Case Number: T 2800/18 - 3.2.08

Spacer profile for a spacer frame for an insulating window unit and insulating window unit

DECISION
of Technical Board of Appeal 3.2.08
of 6 December 2019

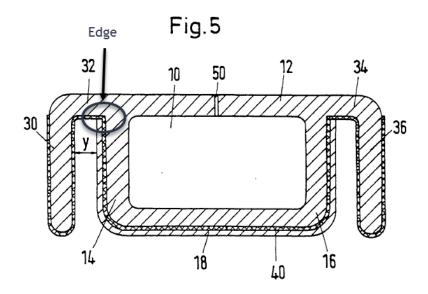
Figure 5 of D3 (an annotated copy being reproduced hereafter) disclosed a spacer profile according to claim 1 of the main request. The metal film 40 comprised a profile on each end that was directed towards the intervening space between the window panes, and the profile was having at least one edge or bend according to feature M4. It was completely enclosed by the profile body as required by feature M3a.

As described in the third paragraph of page 10, the thickness of the metal film 40 could be 0.13 mm. In the first paragraph on page 12, it was disclosed that the profiles of D3 were cold bendable.

Consequently, the profile on Figure 5 showed all the features of claim 1 of the main request.

Feature M3 required that the <u>end</u> of the metal film which was closest to the intervening space had a profile. The profile therefore included the absolute end point of the metal film. What the appellant had identified as an edge of a profile in Figure 5 was not at the end of the metal film 40. Feature M3, and consequently also feature M4 was therefore not disclosed in D3.

Should the part of the metal film identified by the appellant be seen as an edge of the profile, it could only be part of the profile which would then also include the rest of the metal film up to its absolute end point. As seen in Figure 5 and described on page 17, lines 1 to 7 of D3, only the part of the metal film 40 which the appellant identified as an edge was enclosed by the profile body, but the rest of the profile of the metal film, including its end, was not. Feature M3a was therefore not disclosed.

It followed that the spacer profile in Figure 5 of D3 did not show features M3, M4 and M3a of claim 1 of the main request.

Feature M3 defines that the metal film comprises a profile on each <u>end</u> that is directed towards the intervening space between the window panes. The word "end" normally means the part of an object which includes its extremity. The skilled person would therefore understand feature M3 to require that the profile includes the respective end points (or actually edges) of the metal film.

Therefore, if following the appellant's opinion and regarding the part of the metal film 40 which they designated as an edge of the profile (according to feature M4) of the spacer profile in Figure 5, the part of the metal film which extend further from this "edge" - along the plastic parts 30 and 36 respectively - towards and including the end point of the metal film must also be seen as part of the profile. This part of the profile is however not enclosed by the profile body as required by feature M3a.

Consequently, the subject-matter of claim 1 differs from the spacer profile disclosed on Figure 5 of D3 at least in feature M3a. It is therefore new.
